SAN JOAQUIN AREA FLOOD CONTROL AGENCY

5.1) Consideration of the Addendum to the Final Environmental Impact Report; Approval of Alternative Dryland Levee Improvements for the Mossdale Tract Area Urban Flood Risk Reduction Project; and Authorization to File the Notice of Determination

Figure 1
Proposed Dryland Levee Components Overview

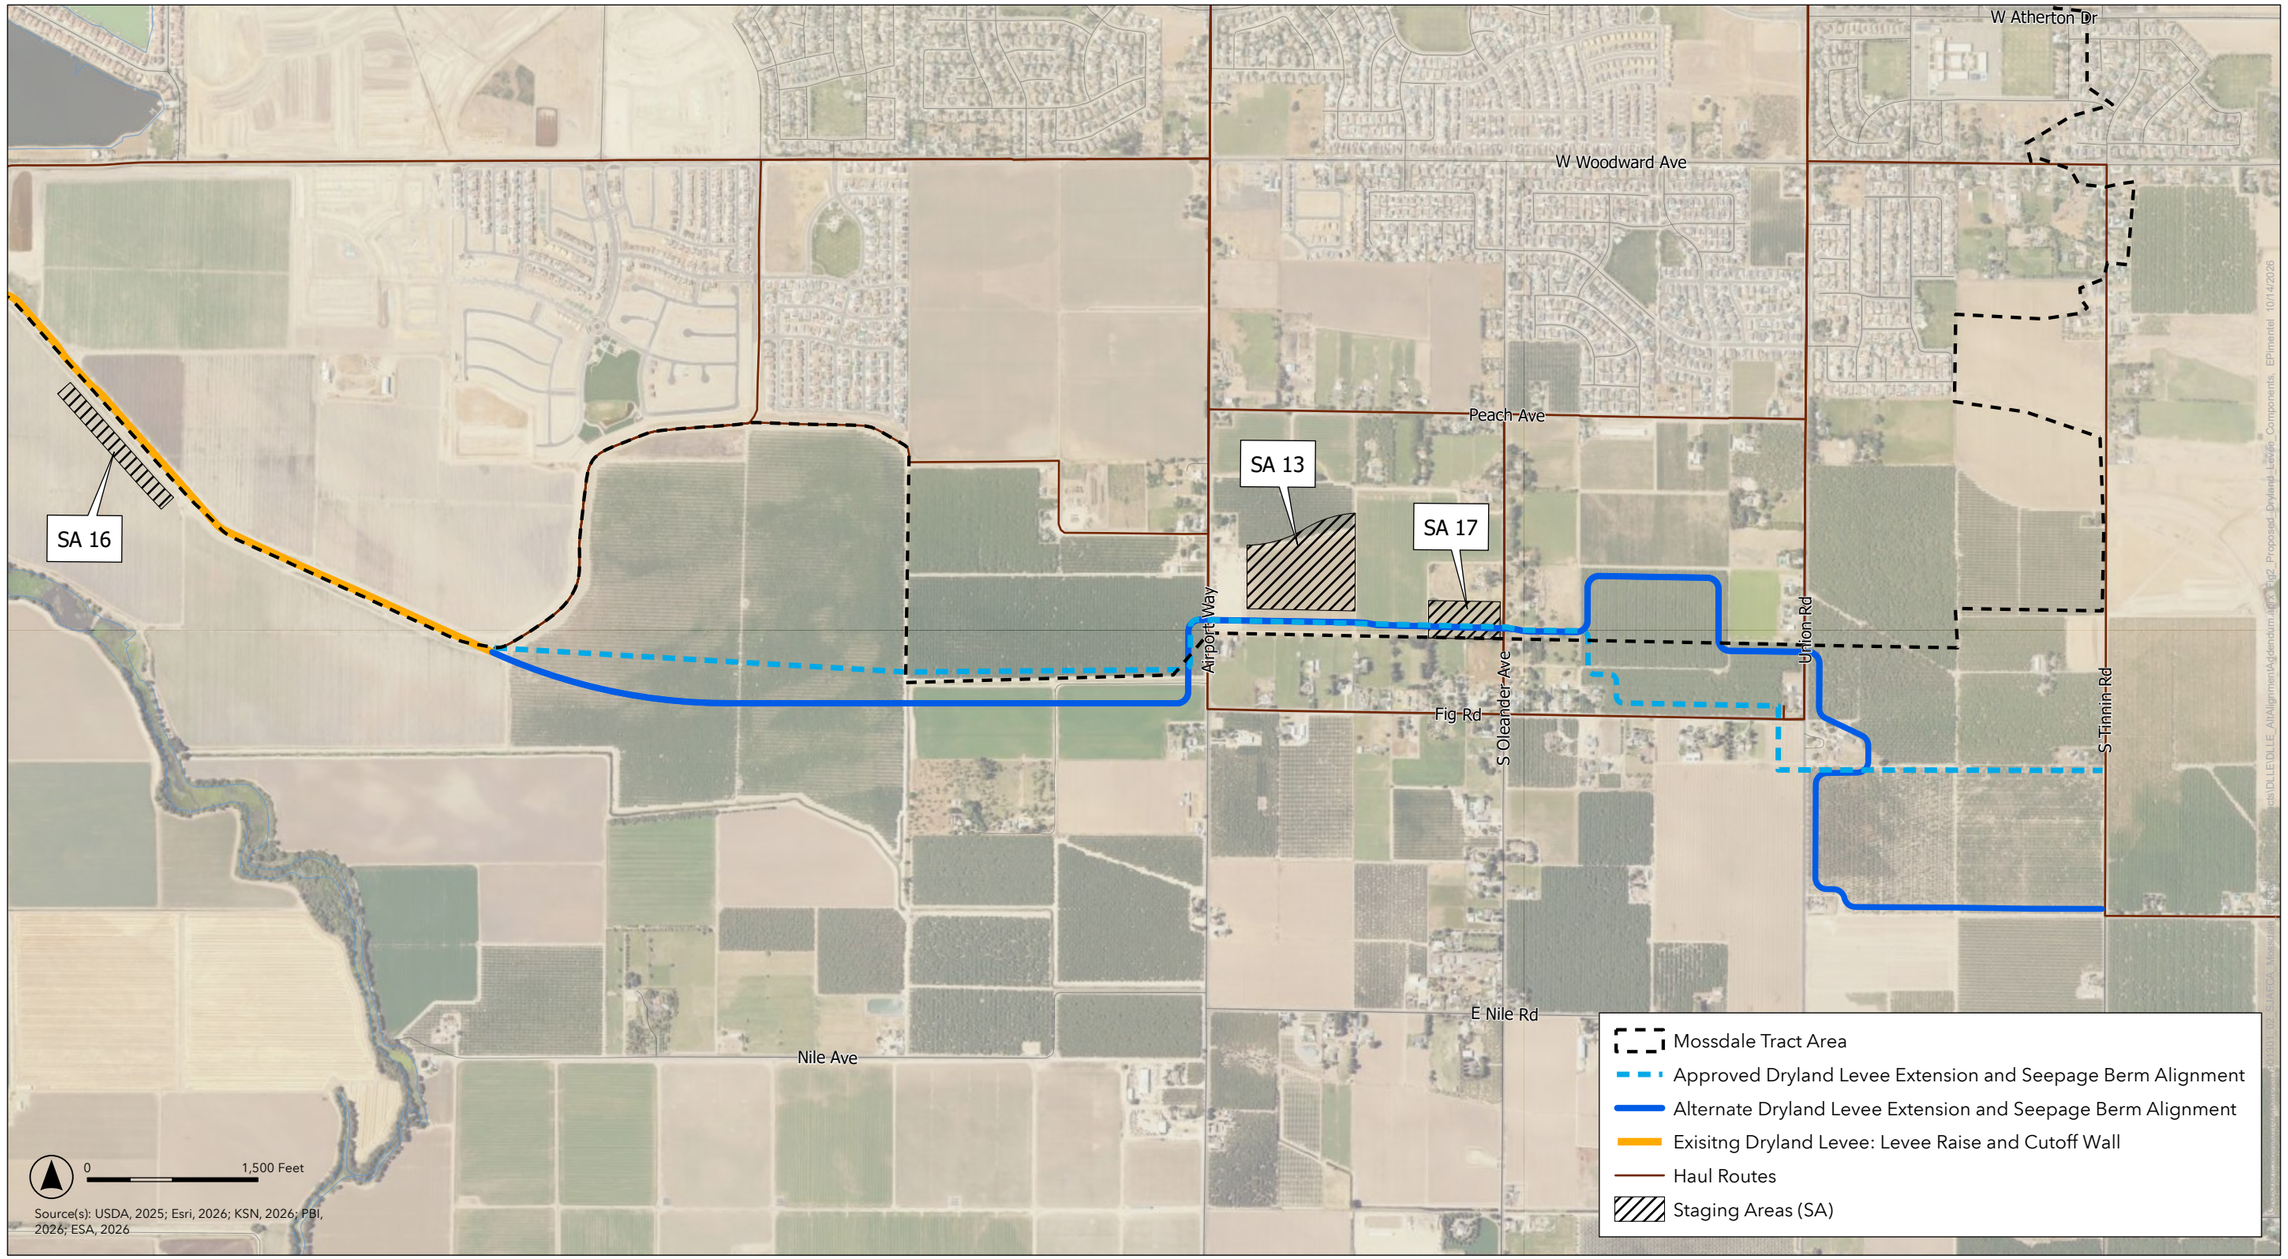
The certified EIR anticipated a seepage berm would be constructed along the existing dryland levee. However, under the proposed changes to the approved project, a cutoff wall would be constructed within the existing dryland levee instead. Overall, the proposed dryland levee cutoff wall (see Figure 1) would use similar construction methods, materials, and equipment as those described for cutoff wall construction in the certified EIR. The cutoff wall would be constructed at the levee centerline to depths that would be sufficient to minimize seepage both through the levee and beneath it to meet or exceed U.S. Army Corps of Engineers and State of California Central Valley Flood Protection Board levee design criteria.

The alternate dryland levee extension alignment is approximately 3.5 miles long and would roughly follow the approved dryland levee extension alignment described in the certified EIR before diverging near Oleander Avenue and Fig Road and continuing to Tinnin Road. The alternate dryland levee extension alignment would begin at the eastern end of the existing dryland levee and traverse east to Airport Way, approximately 200 feet south of the approved dryland levee extension alignment described in the certified EIR. At this point, the route follows the same path as the approved dryland levee alignment, continuing east from Airport Road and crossing Oleander Avenue. Approximately 650 feet east of the crossing at Oleander Way, the alternate dryland levee extension alignment diverges and traverses around an orchard before continuing east and crossing Union Road, traveling south along Union Road for 0.5 mile, traversing around two rural residential properties, then turning east and terminating at Tinnin Road.
